4. Cooling System

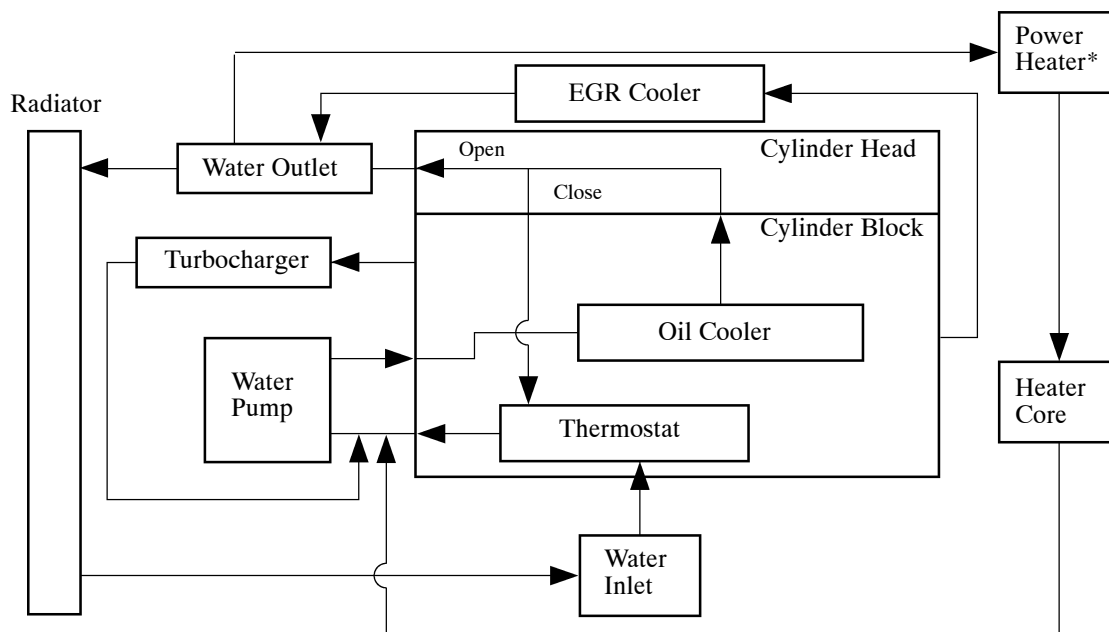
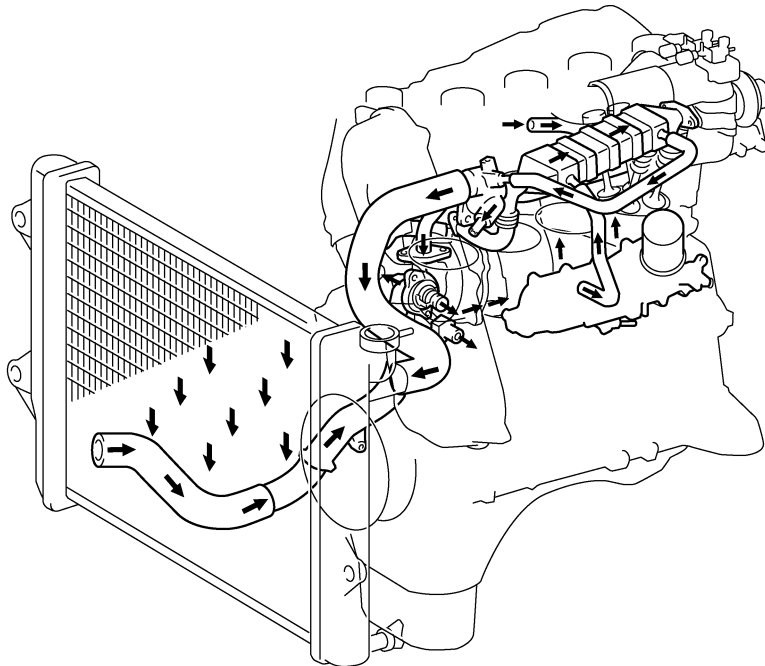
Along with the change in the nozzle vane control motor for the turbocharger from a step motor to a DC motor, the circuit for cooling the motor has been discontinued.
